Internal Referral Brief for MPRG

SUBMISSION TO MAJOR PROJECT REVIEW GROUP

AGENDA ITEM NO.	
DATE OF MEETING	7 DECEMBER 2016
SUBJECT	DA 201630153 RECONSIDERATION – BLOCK 8 SECTION 35 FORREST
BRANCH	PLANNING DELIVERY
PRESENTED BY	SYED ALI

DRAWING
POS PLAN

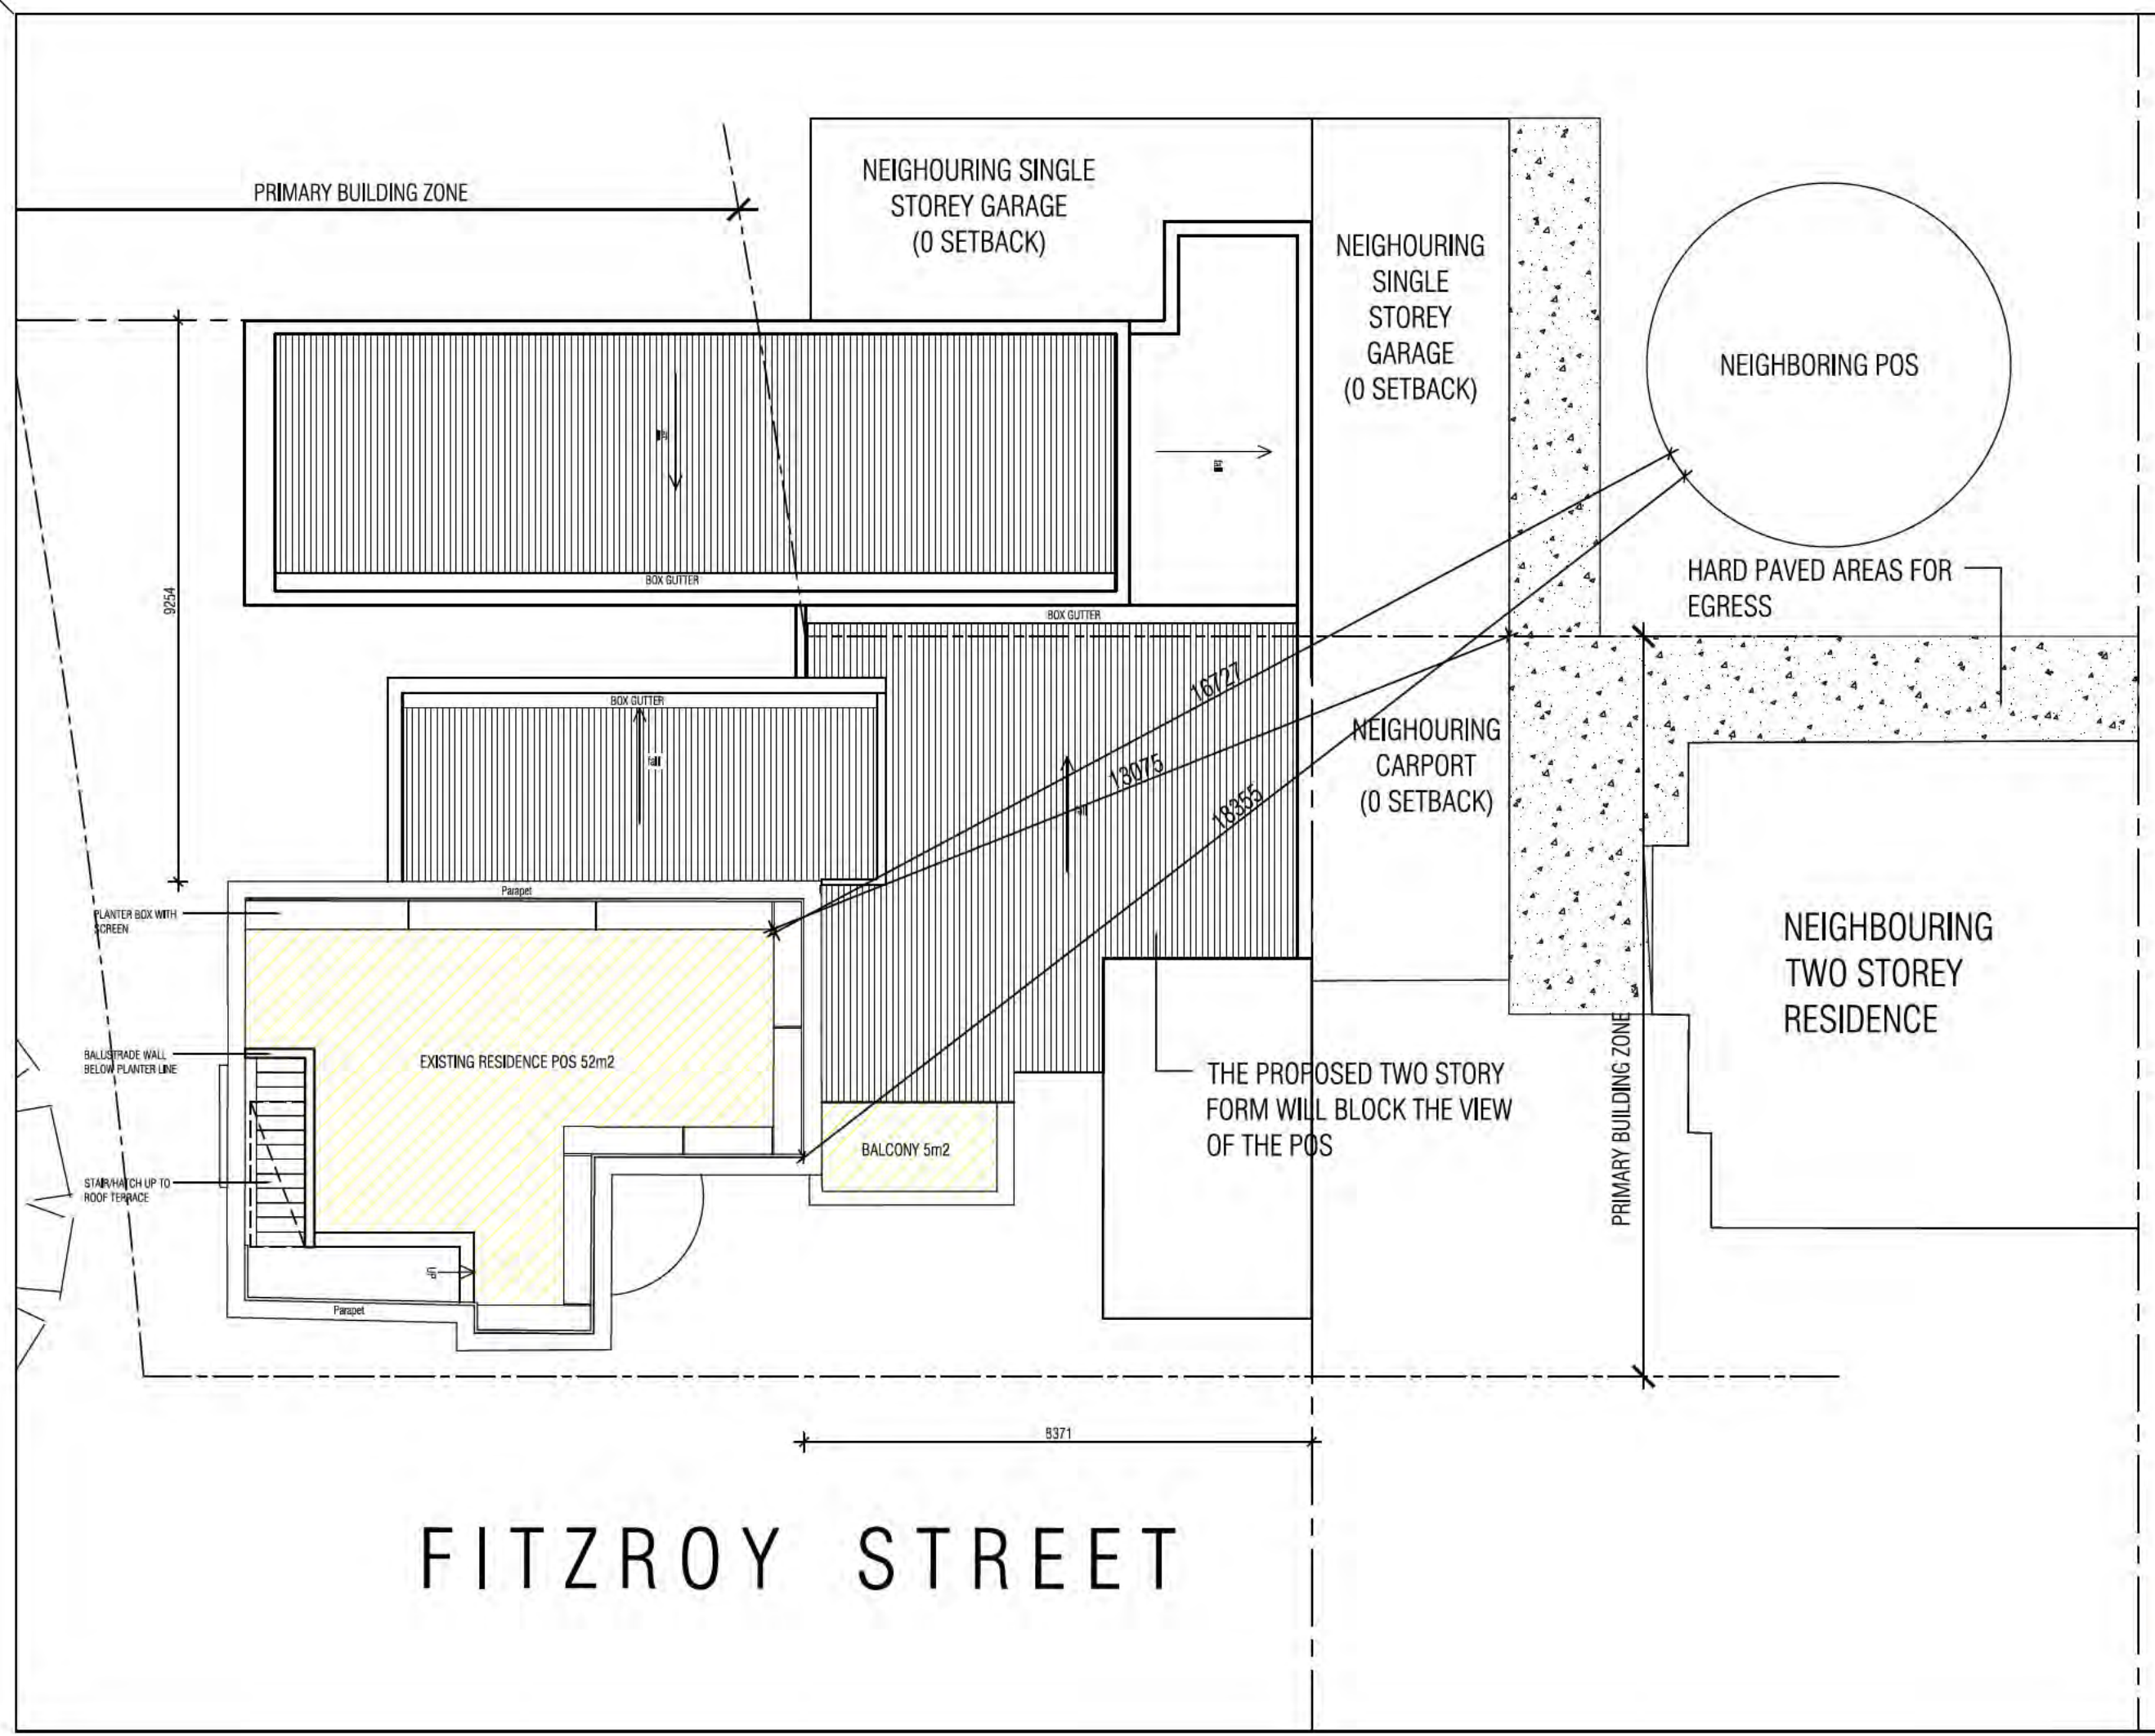
- o Principal Private Open Space (R60, MUHDC)

The proposed principal private open space is located on the rooftop. (refer to attached photo). The area is accessed directly by a stair from the living room and meets the requirement of the Rule being more than 24m².
